Certificate of Appropriateness—Amended

Property	801-803, 805, & 807-809 N. CASS ST.	Cass & Wells Historic District
Description of work	Construct connector addition between 801-803 N Cass St and 807-809 N Cass St on vacant lot at 805 N Cass St and enclose the space. Begin site work, foundations/footings, and framing of structure and roofing. Demolition of 2nd story north balcony on 801-803 building. Demolition of oriel window on south side of 807-809 building. Remove aluminum and vinyl siding from existing buildings. Rebuild ground floor façade of 807-09 Cass building. Remove gutters and downspouts from both buildings as needed route future drainage across flat roof of infill building. Additional specifications are noted on drawings.	
Date issued	2/28/2017	Amended 2/13/2018 PTS ID 114185 COA

Proposed Cass Street elevation.
Unapproved items are crossed out.

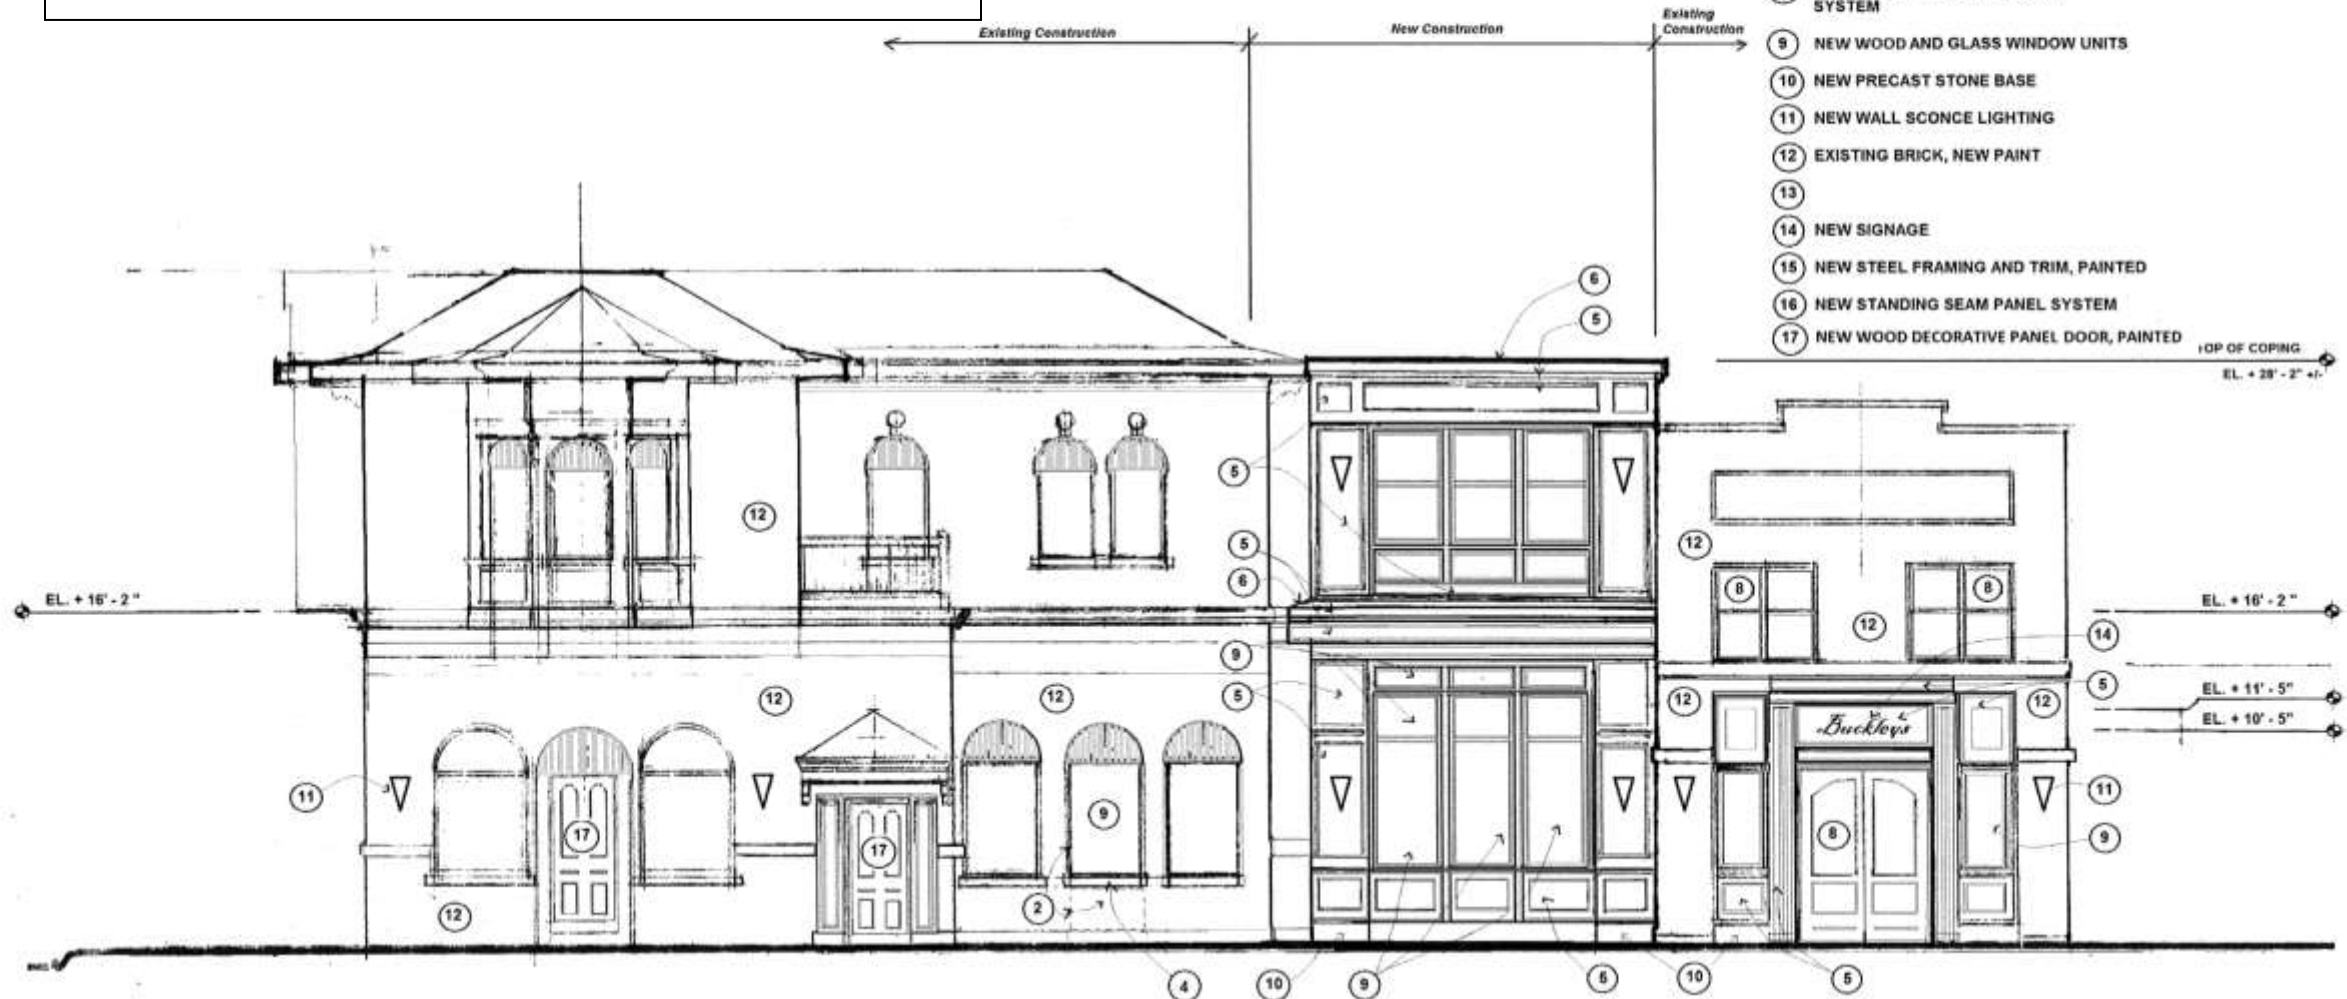
Doors and windows on infill building and 807-809 building are to be as shown. Second floor east windows on 807-09 building are not to be altered.

Windows on 801-803 building may be replaced with two-over-two wood windows within the existing opening.
